RYLANDS BUILDING MANCHESTER

PROPOSED DESIGN AMENDMENTS

October 2024

The purpose of this document is to provide supporting information to the amendment applications for Rylands Building, Manchester.

CONSENTED -2 SUB BASEMENT FLOOR PLAN

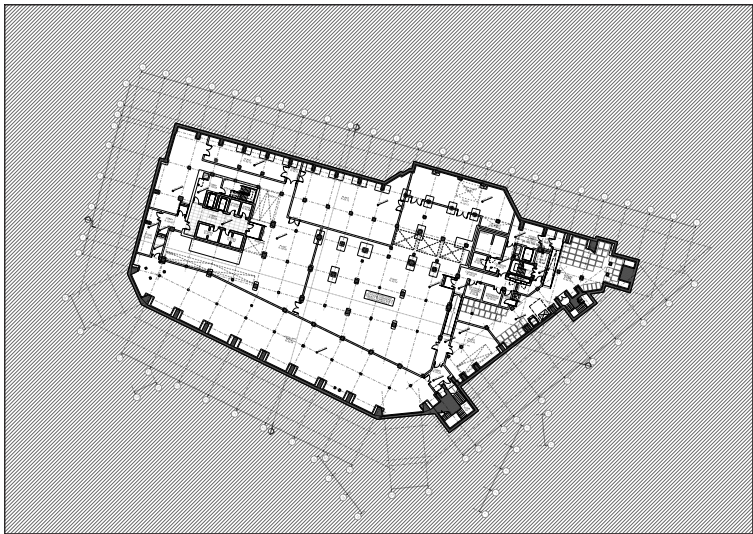
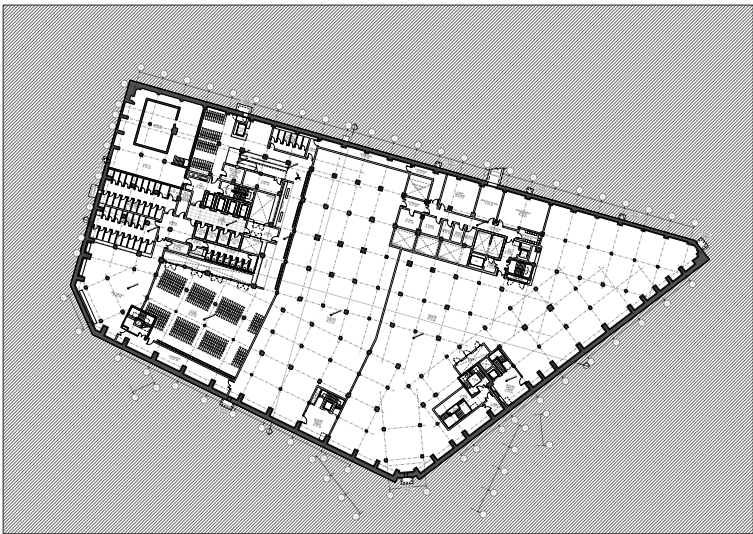
MAIN REFUSE STORE REORGANISED

The main refuse store located at sub-basement has been reorganised to accommodate the ground floor Market Food Hall requirements. Adjacent stores have also been reorganised to improve MEP routing to risers and to accommodate amendments to Core 02.

CONSENTED -1 BASEMENT FLOOR PLAN

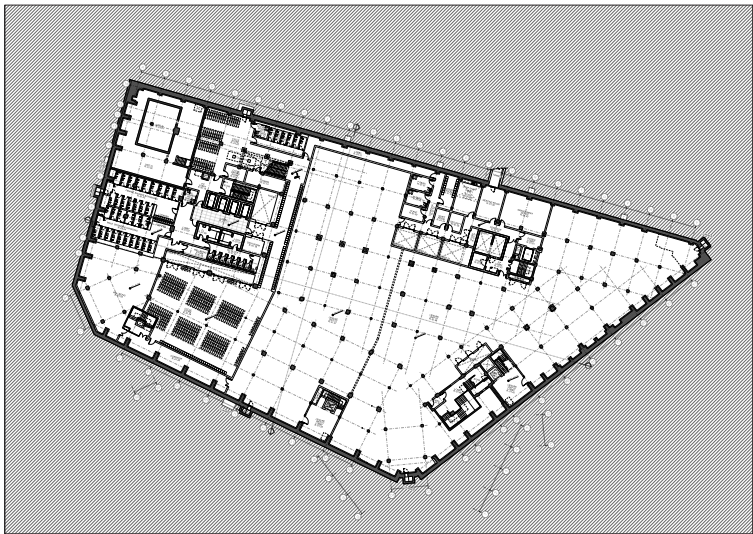
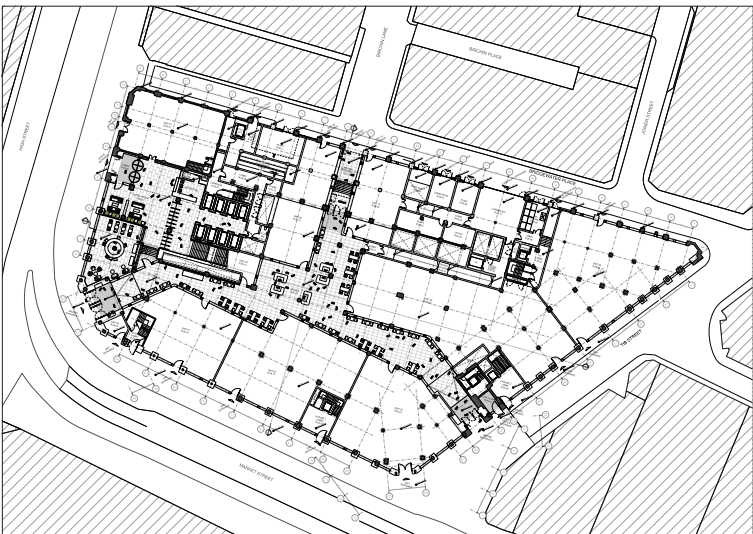
CYCLE LIFT REMOVED & CYCLE RAMP AMENDED TO CYCLE STAIR

The cycle ramp has been replaced with a cycle stair with cycle tracks to accommodate pedestrian movements to and from the cycle store. The amendment creates structural efficiencies with less impact on the existing structural frame. Removal of the cycle lift reduces demolition and the impact on the listed building. A cycle lift function to the cycle store is maintained via Core 01 lifts.

SHOP FRONT AMENDMENTS

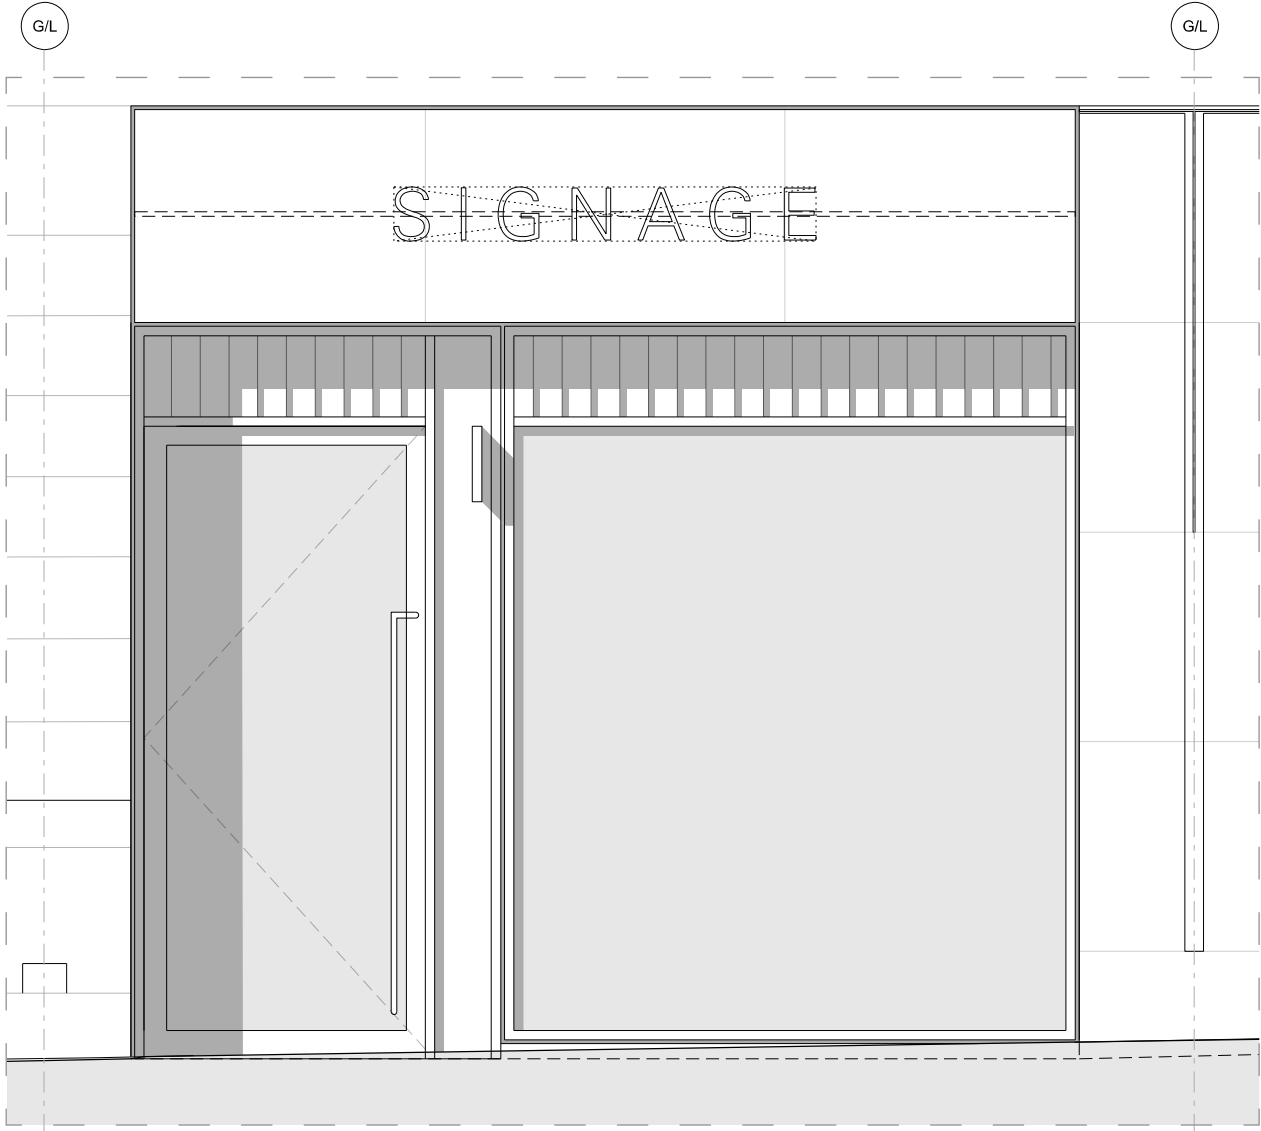
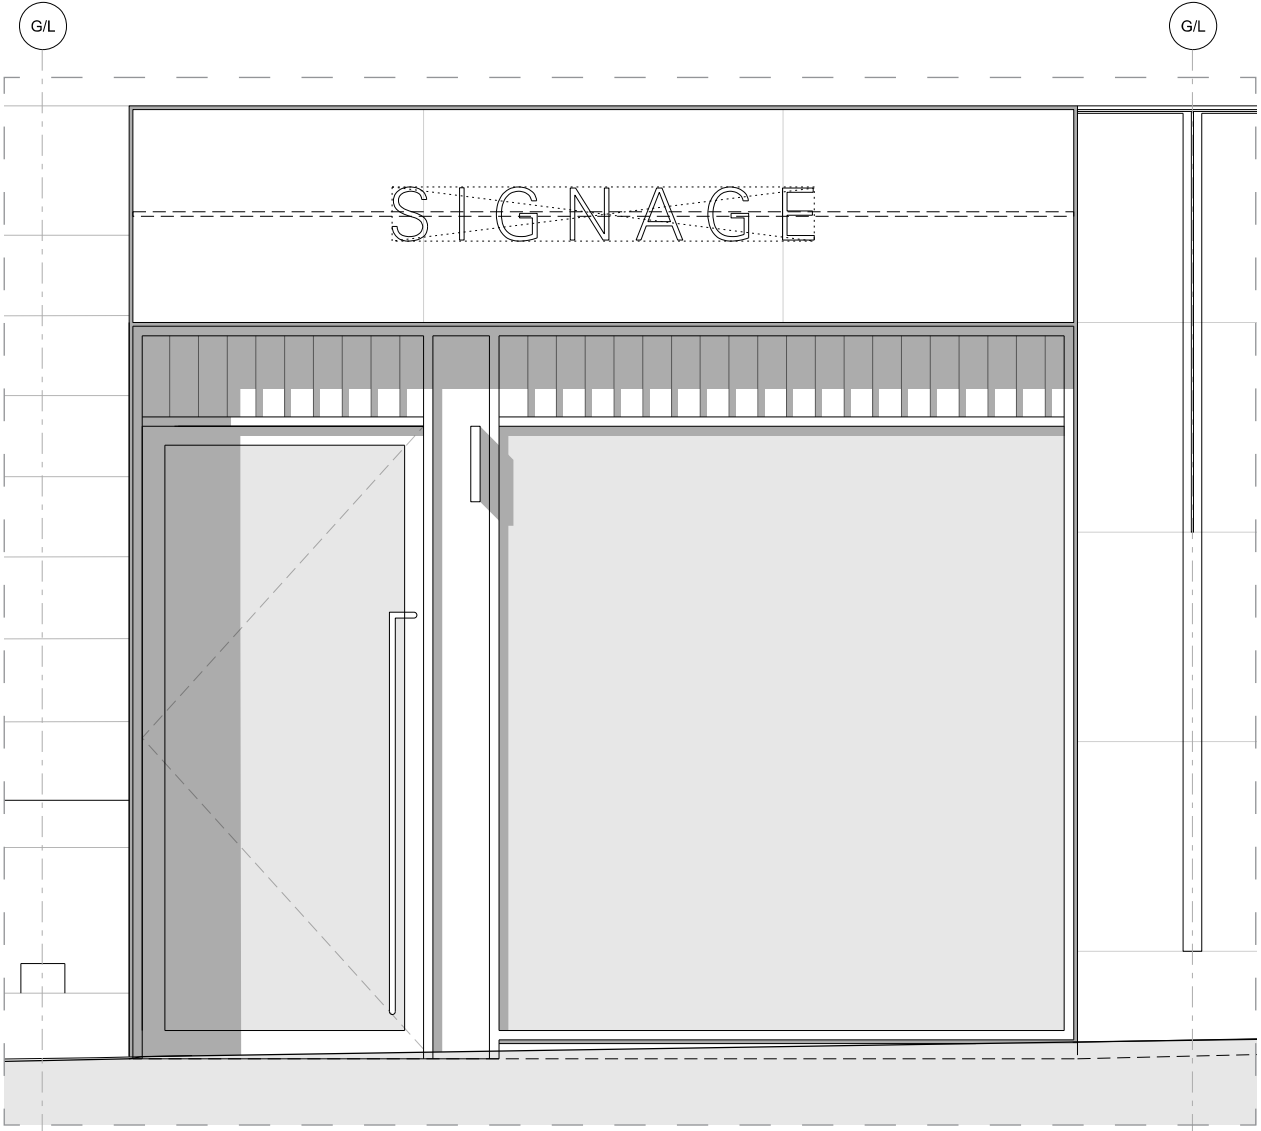
All ground floor shop fronts previously detailed with a double vertical mullion have now reverted to a single mullion detail to create efficiencies. The established design vocabulary from the original consent remains.

VERTICAL DOUBLE MULLION DETAIL AMENDED TO SINGLE MULLION

(APPLIES TO ALL SHOP FRONTS)

CONSENTED 6TH FLOOR PLAN

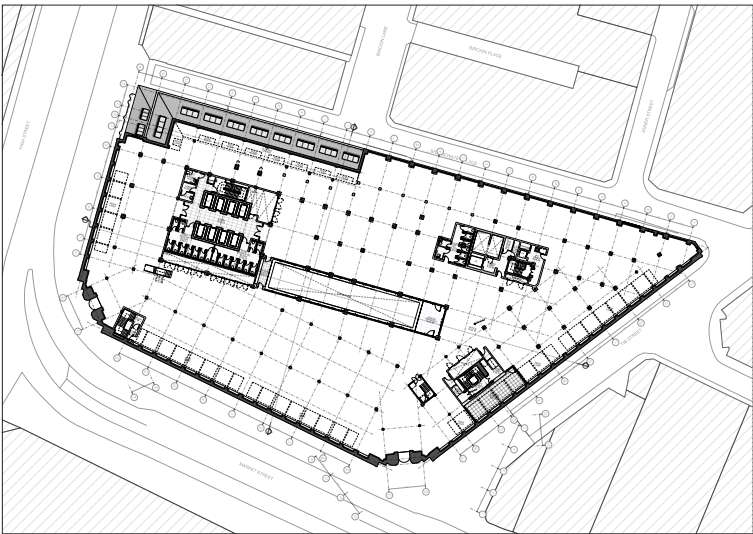
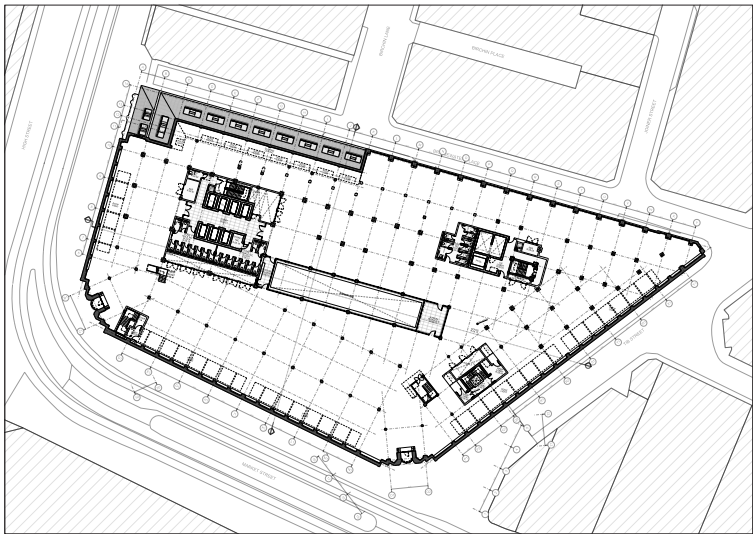
LEVEL 06 WINTER GARDEN OMITTED

The winter garden located on level 06 has been omitted creating more internal net office space. Existing original perimeter roof lights are retained providing natural light into the office spaces below.

LEVEL 06 BALCONIES REUSED FOR TENANT USE

Original balconies at level 06 located on the corner of Market Street and Tib Street are to be reused for office tenant use. The original metal filigree balustrades are low for modern standards, therefore, additional balustrade protection in the form of curved structural glass balustrades located behind the originals provide the required additional protection with minimal visual impact from the street.

EXTENSION UCW CLADDING AMENDMENTS

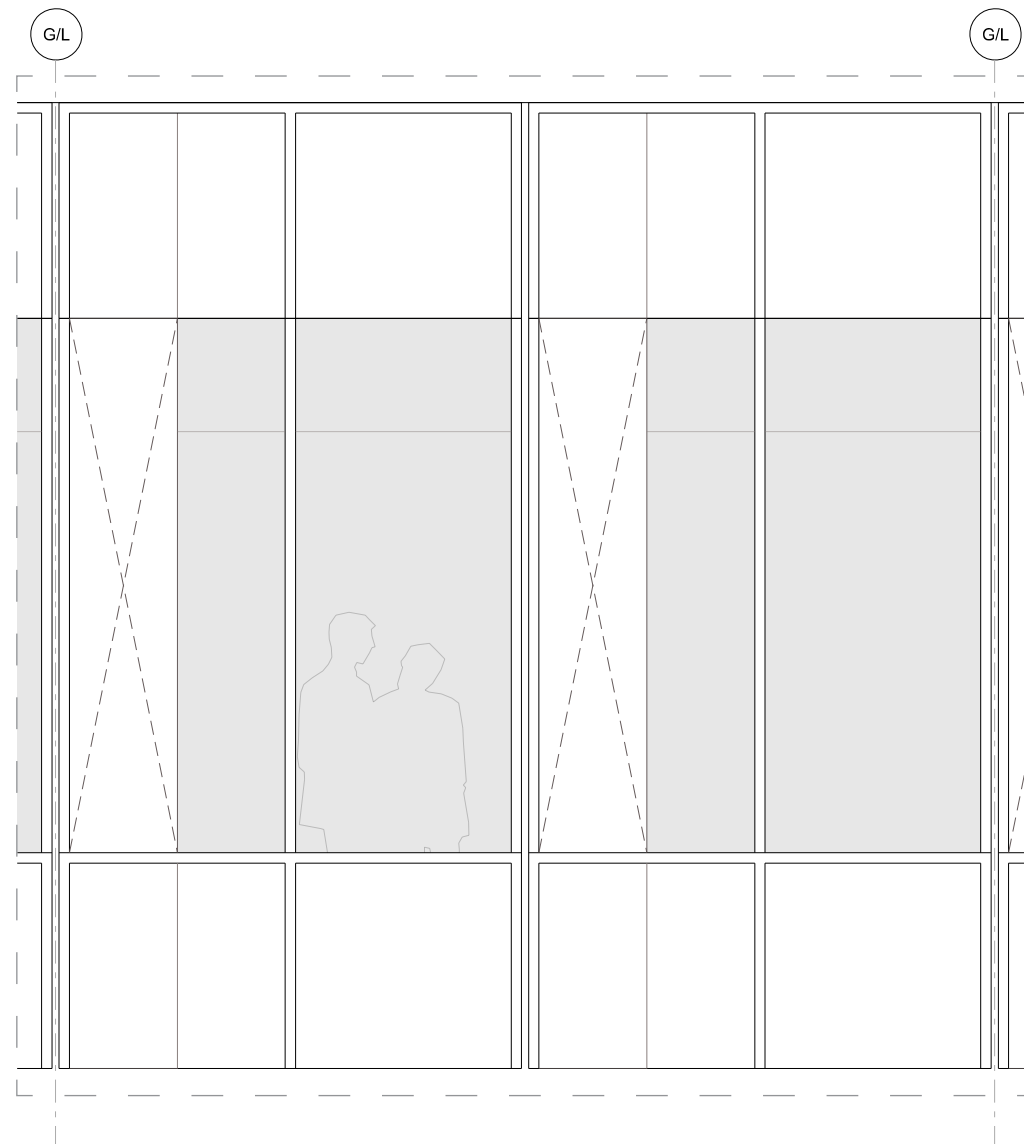
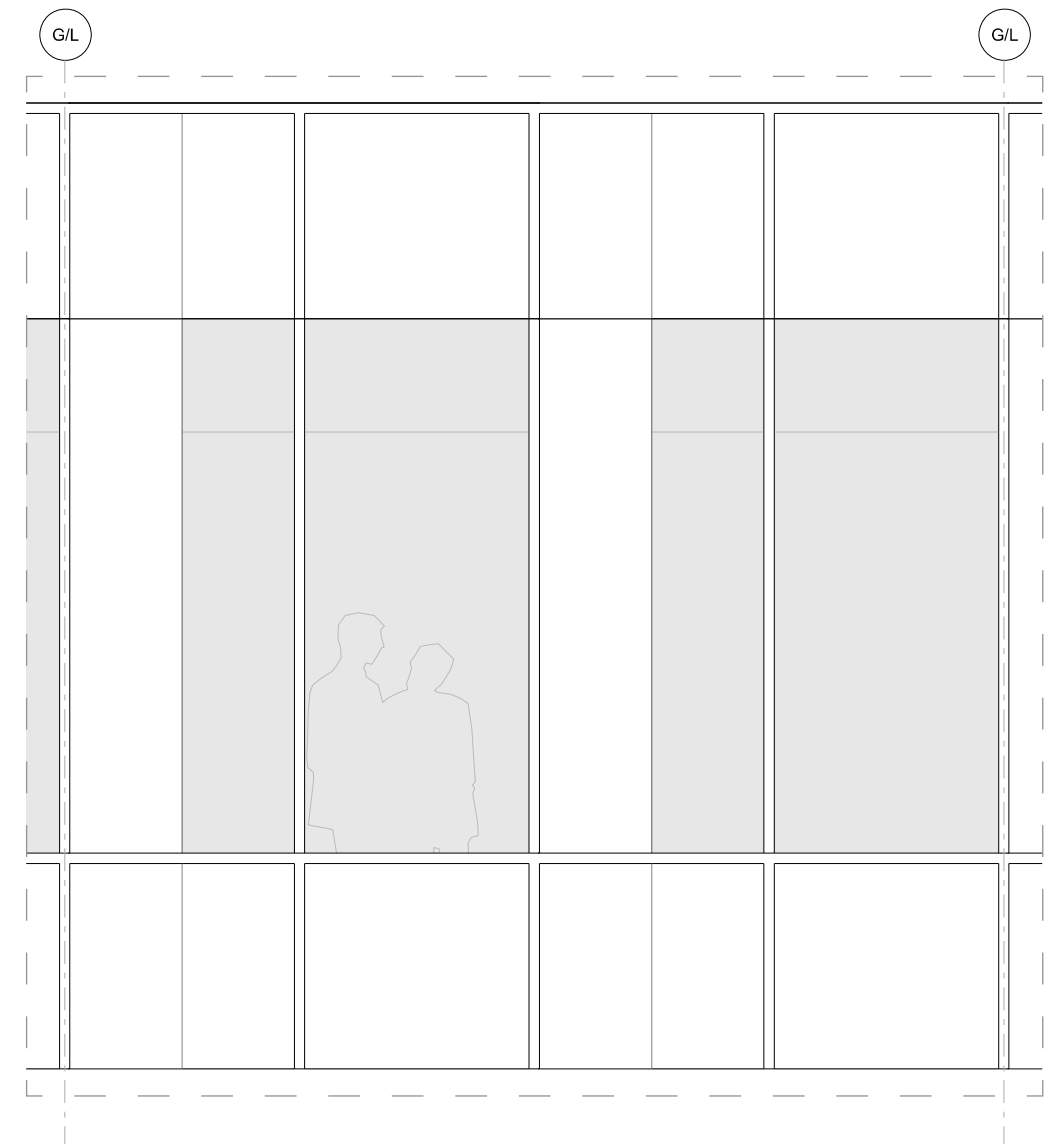
VERTICAL DOUBLE MULLION DETAIL AMENDED TO SINGLE MULLION

ACTIVE OPENING LIGHTS OMITTED IN LINE WITH UPDATED MEP STRATEGY

(APPLIES TO ALL AREAS OF THE EXTENSION UCW CLADDING)

SECTION 01

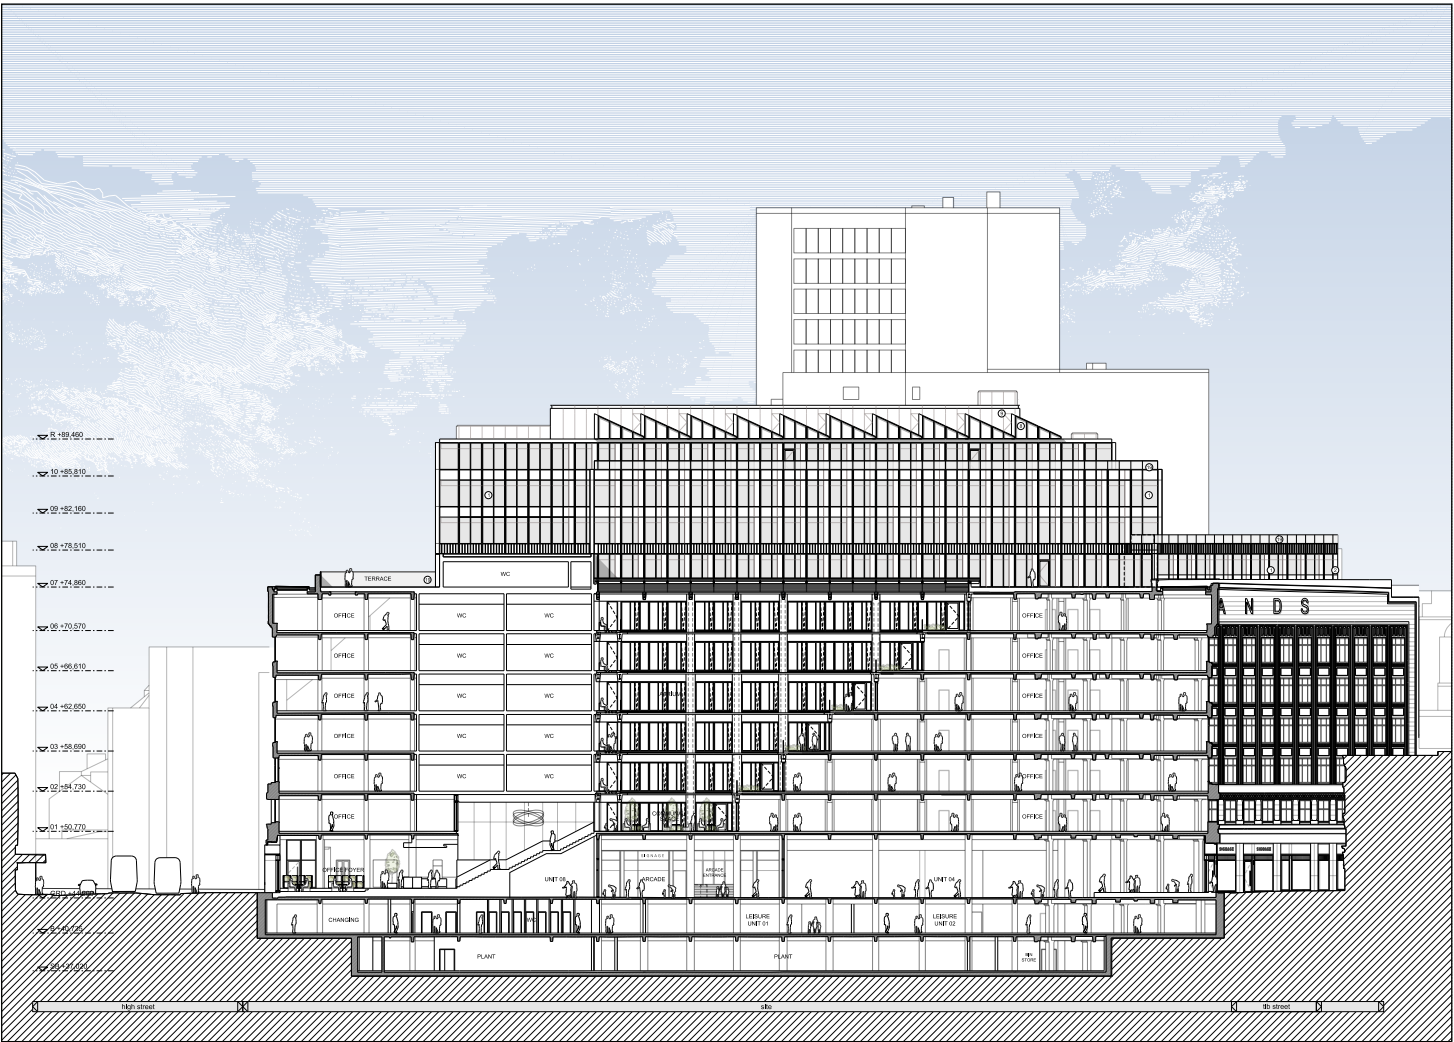
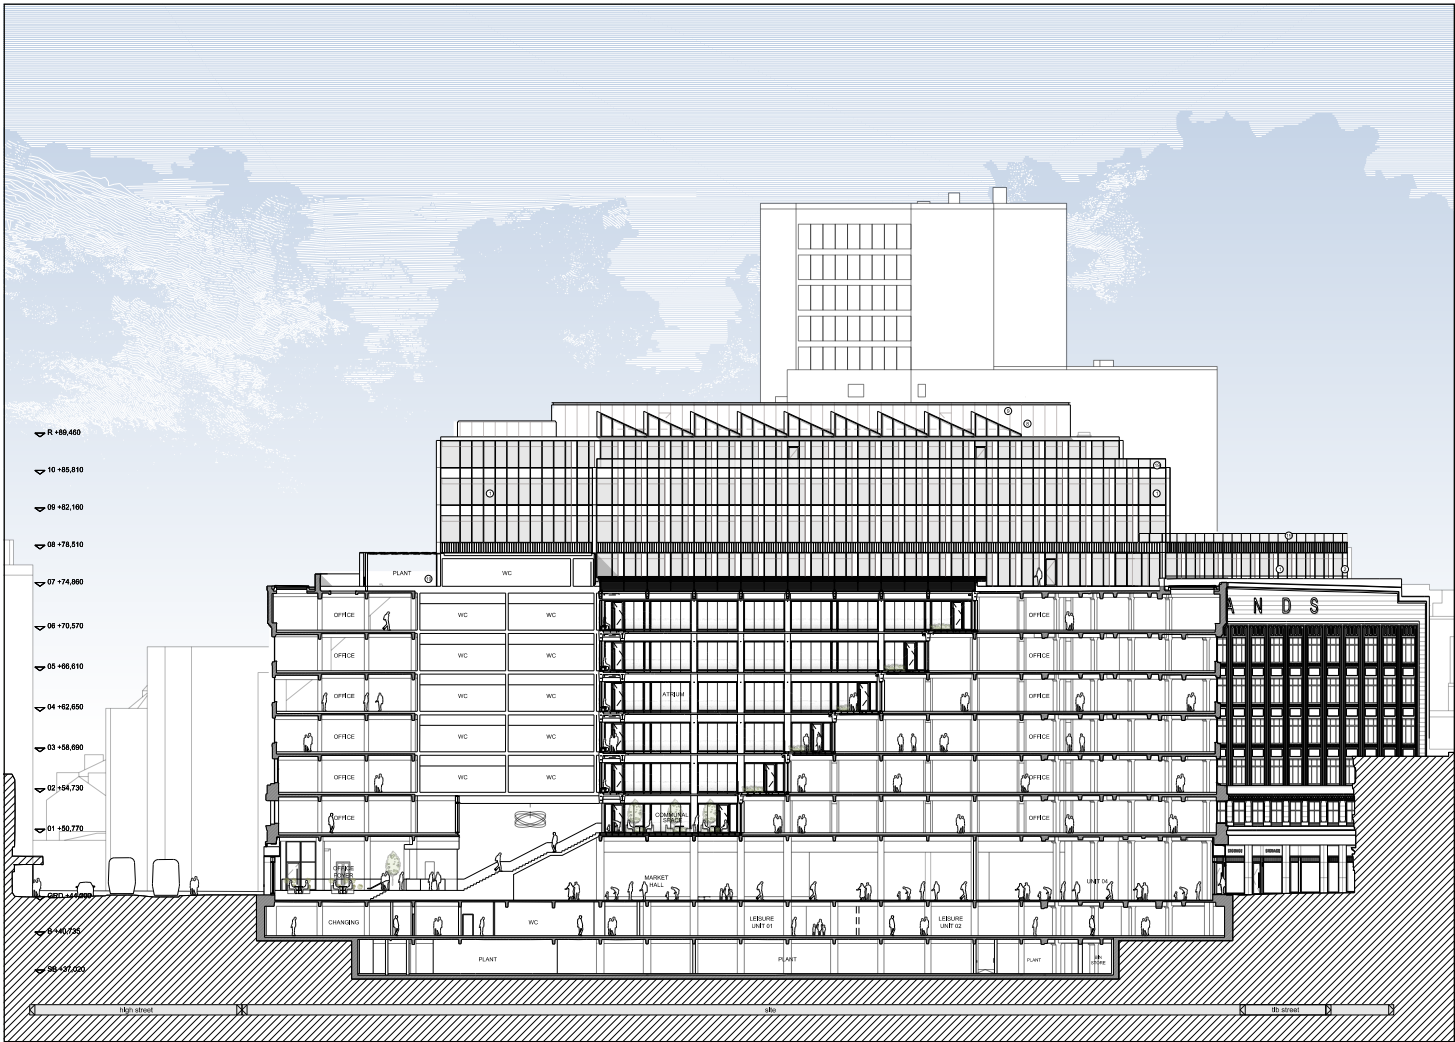
LEVEL 07 PLANT SPACE

SAWTOOTH ROOF DETAILING

LEVEL 11 PLANT SPACE
